NUMBER
GSD146404

LINE	QUANTITY	UOP	CAT. NO.	ITEM NUMBER	UNIT PRICE	AMOUNT
ADDENDUM NO. 1						
THIS ADDENDUM IS ISSUED TO MODIFY THE ORIGINAL SOLICITATION PER THE ATTACHED DOCUMENTATION.						
0001	1	LS		968-42		
				CAMPUS CONCRETE REPAIRS		
0002	1	SF		968-42		
				ADDITIONAL SIDEWALK REPLACEMENT PER SQ. FT.		
0003	1	LF		968-42		
				ADDITIONAL SIDEWALK JOINT REPAIRS

SOLICITATION NUMBER: GSD146404
Addendum Number: 1

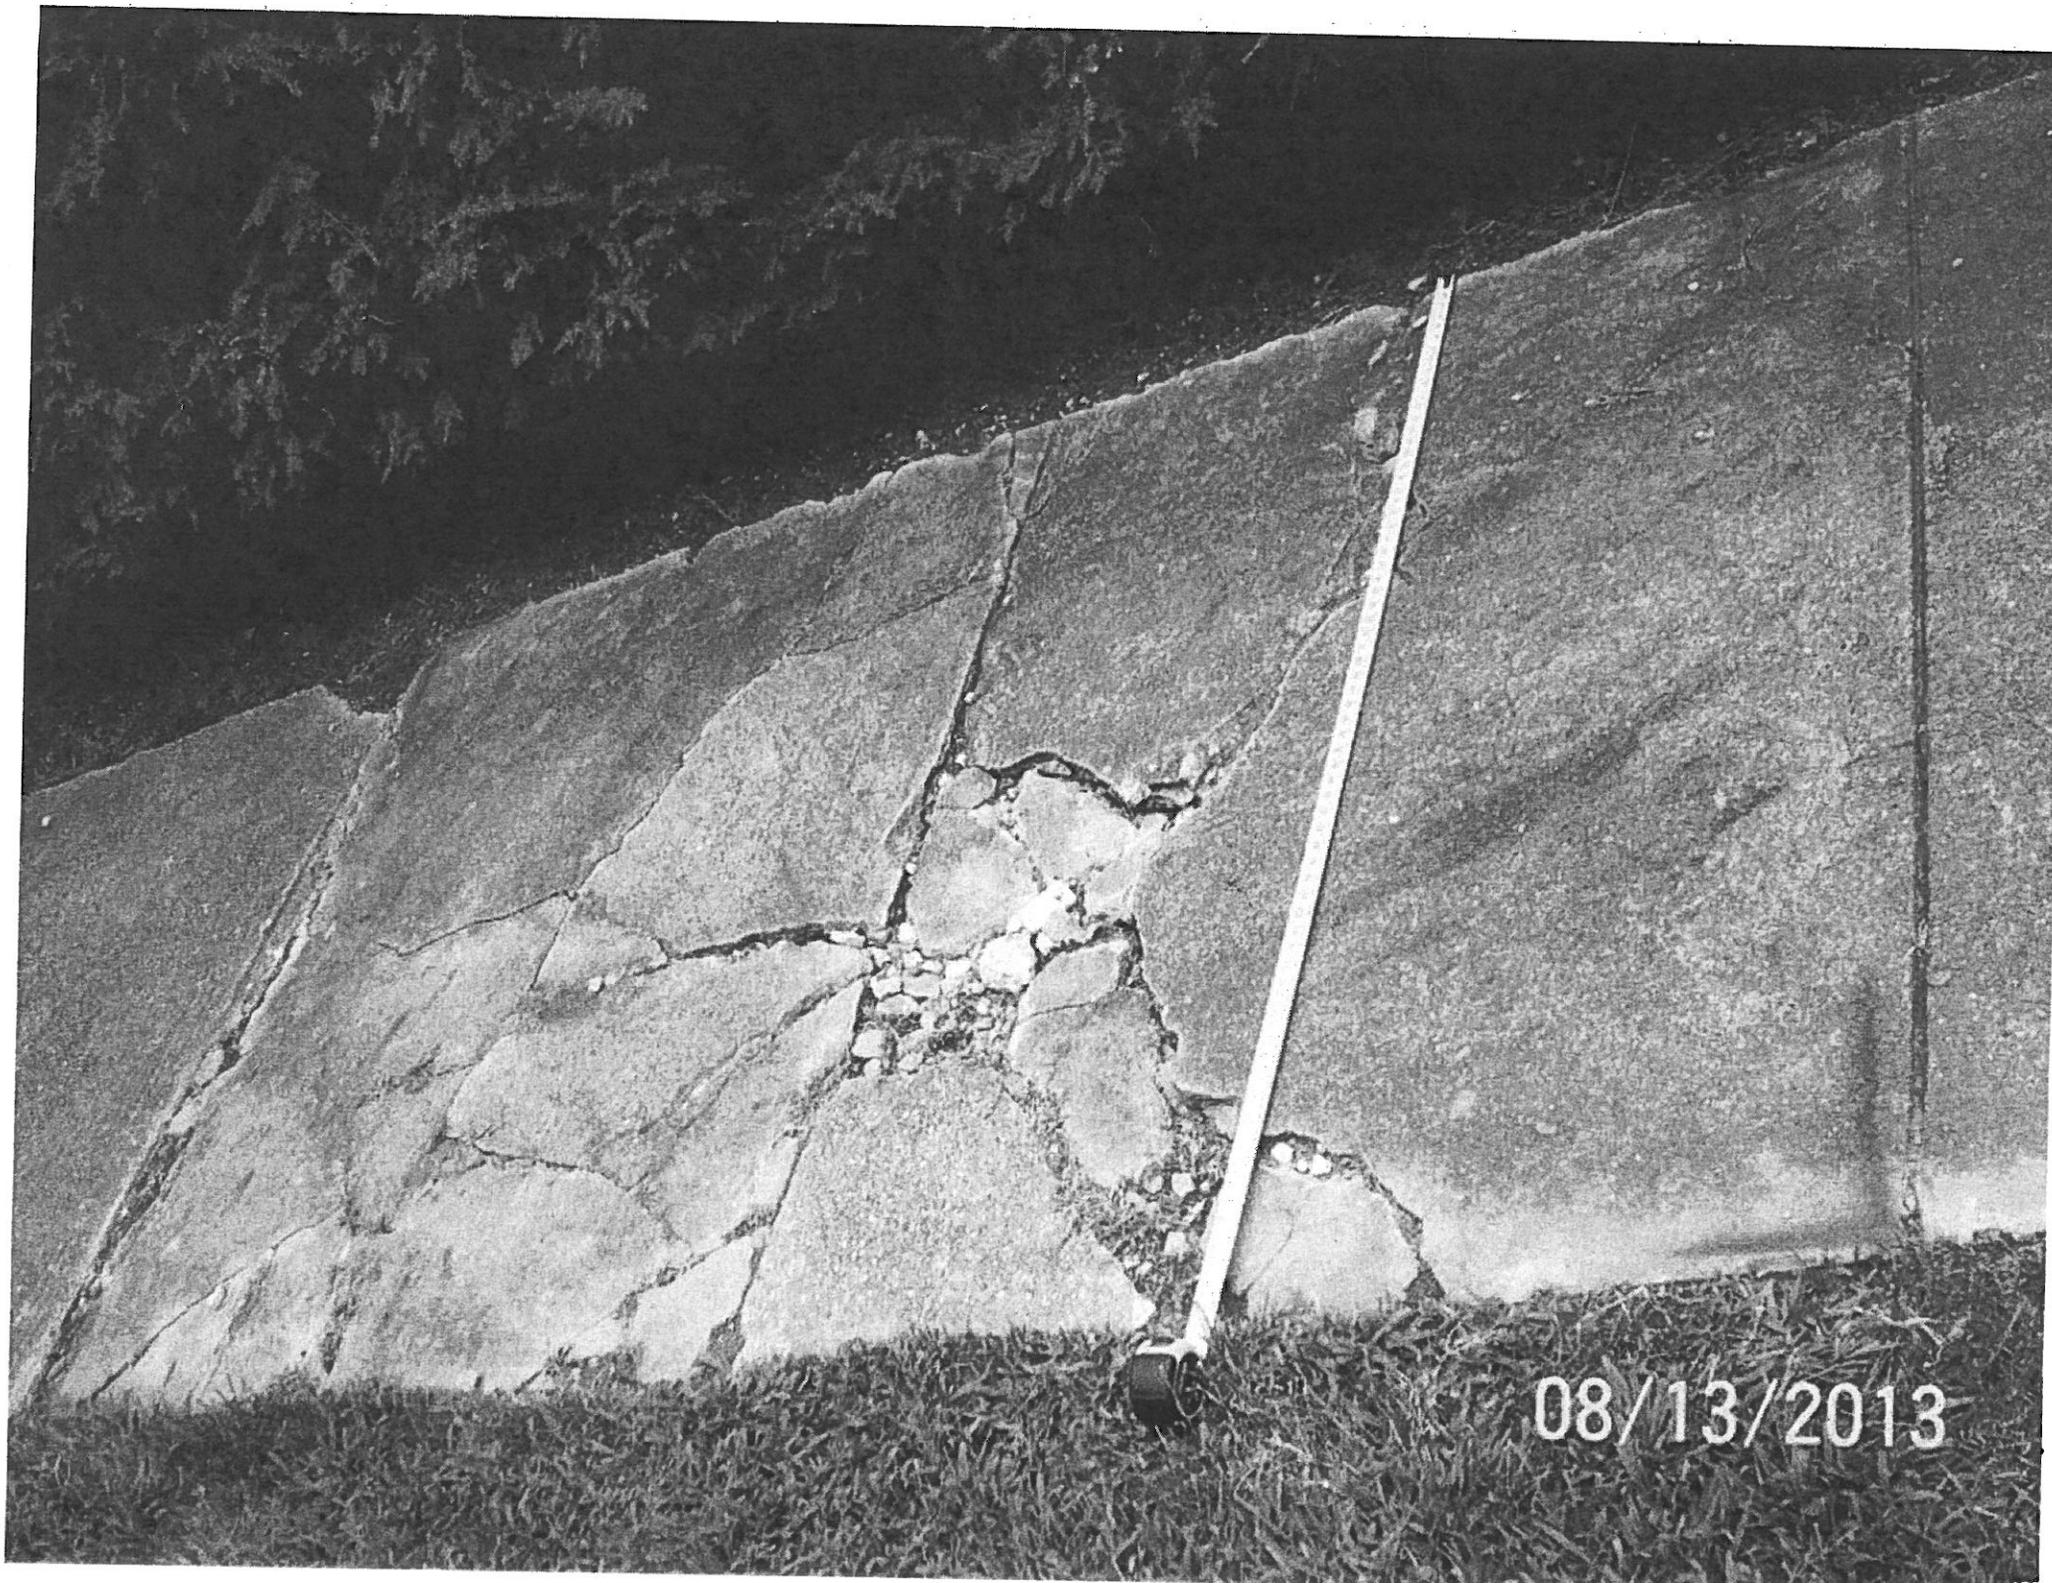
Q5. #36 can a number of stones to be replaces or square footage number be provides for bidding?

A5. For #5, the instructions should be to sawcut the edges of limestone in areas to be repaired to a minimum depth of $\frac{3}{4}$ inch, provide mortar patch with color to match the existing limestone. Multiple damaged edges/corners will be sawcut and patched with a total aggregate area not to exceed five (5) square feet included in bid. Project manager will field determine those areas to be patched.

*Note contractor shall maintain existing caulk joint thickness between stone pavers. Owner will caulk joints at completion of repairs.
